PUBLIC INTEREST REVIEW FOR GROUND WATER APPLICATIONS

TO: Water Rights Section Date March 14, 2012
 FROM: Ground Water/Hydrology Section Michael Zwart
Reviewer's Name
 SUBJECT: Application G- 17527 Supersedes review of February 14, 2012
Date of Review(s)

A. GENERAL INFORMATION: Applicant's Name: Justin and Stephanie Bowen County: Harney

Application G-17527, Justin & Stephanie Bowen (Rereview)

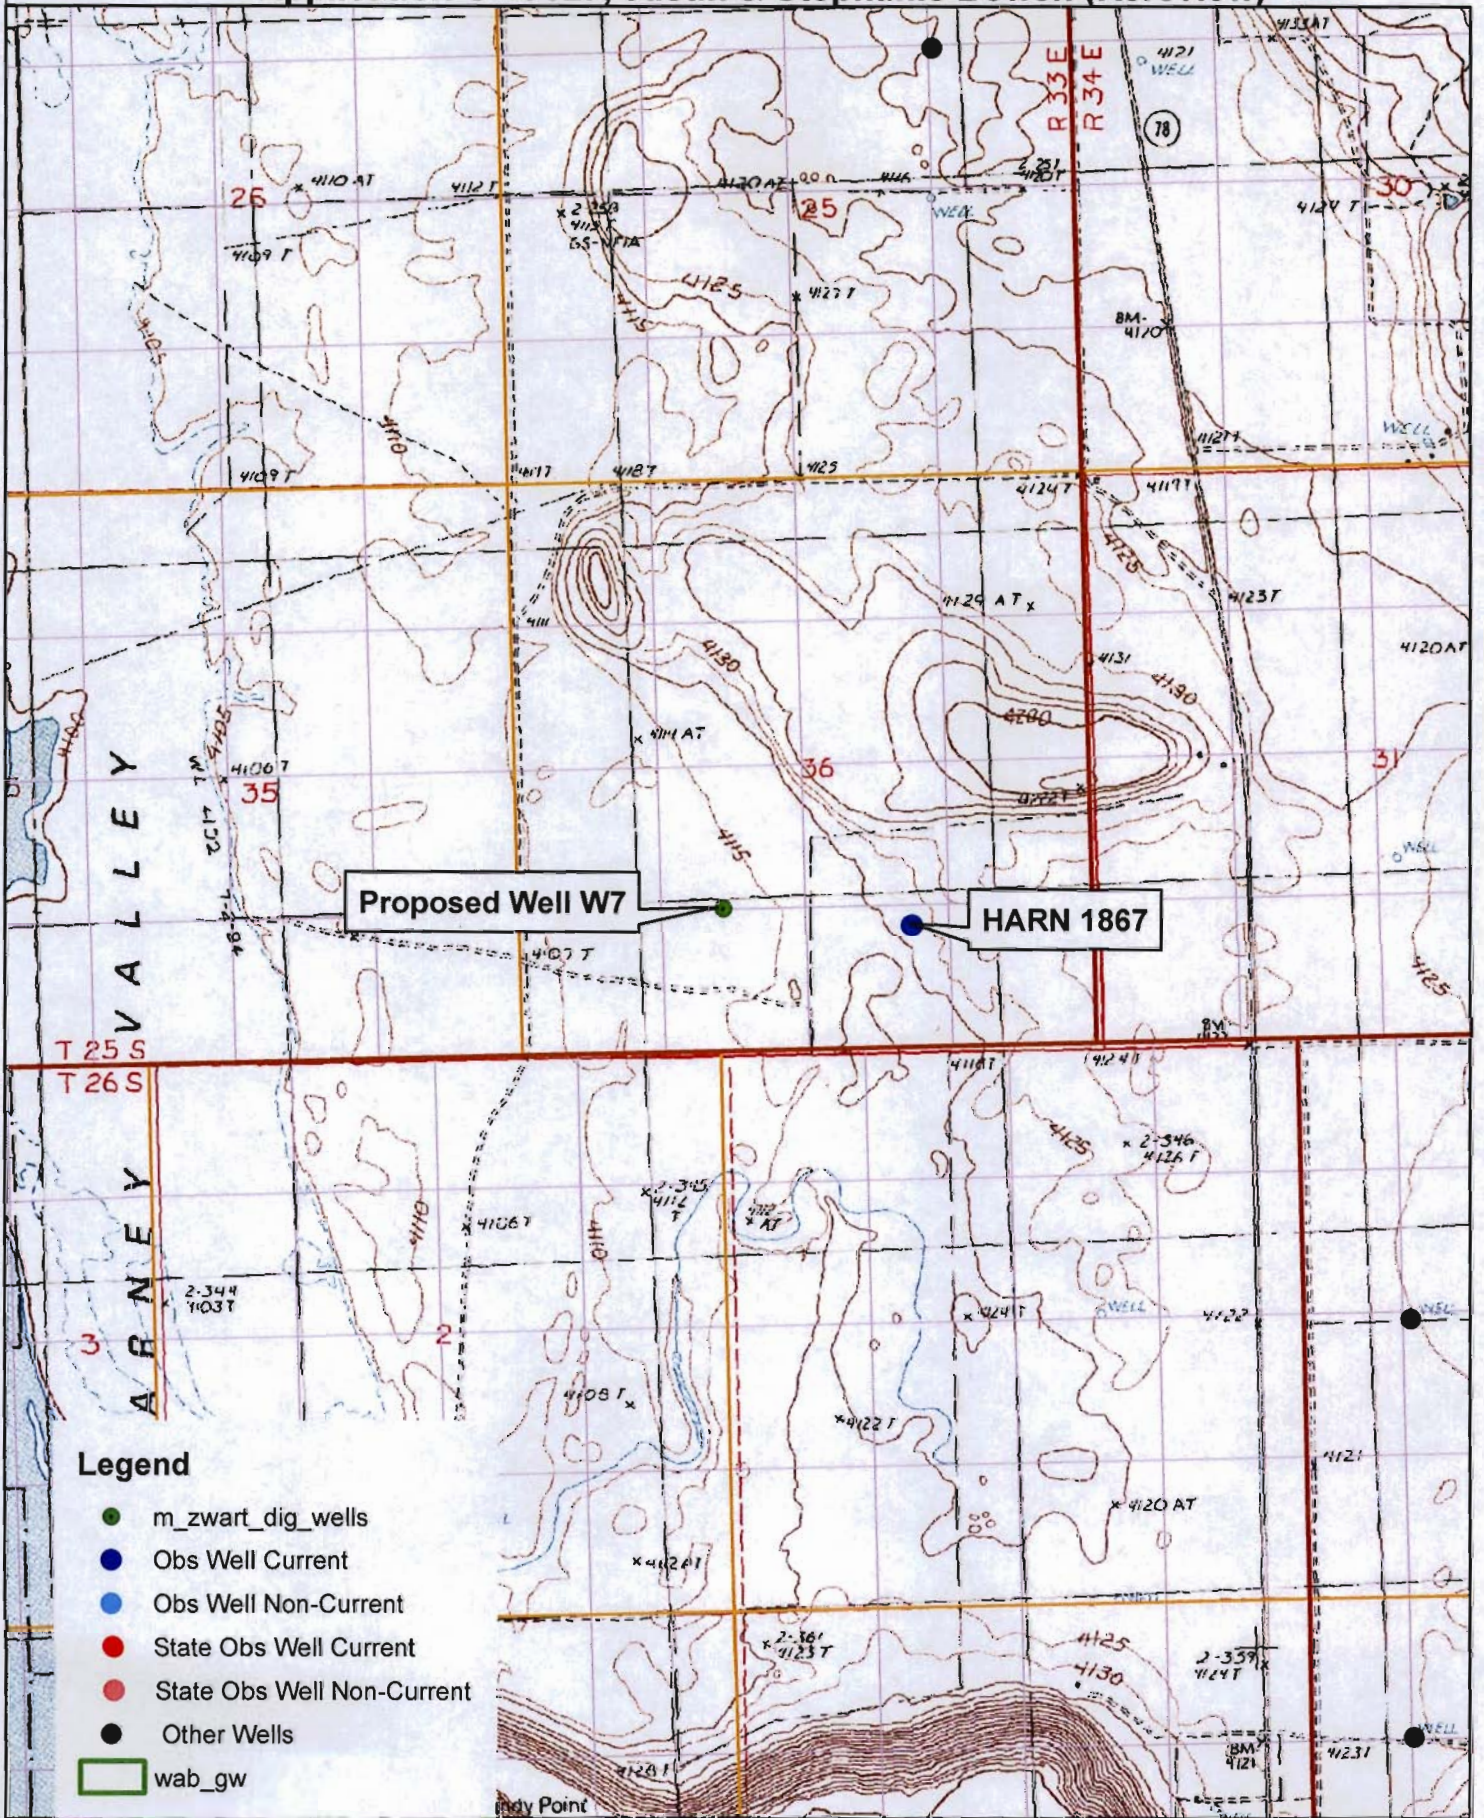
A4. **Comments: *Unusual metes & bounds: Note that NE corner Sec. 1 is offset from the SE corner Sec. 36. Well 2 (W7) is proposed as an alternative to using Well 1 solely if proposed deepening of it does not result in sufficient water.**

Basis for aquifer hydraulic connection evaluation: *Both the surface water elevation and distance to the well will vary as the lake level changes. It is likely that the aquifer penetrated ultimately discharges to Malheur Lake.
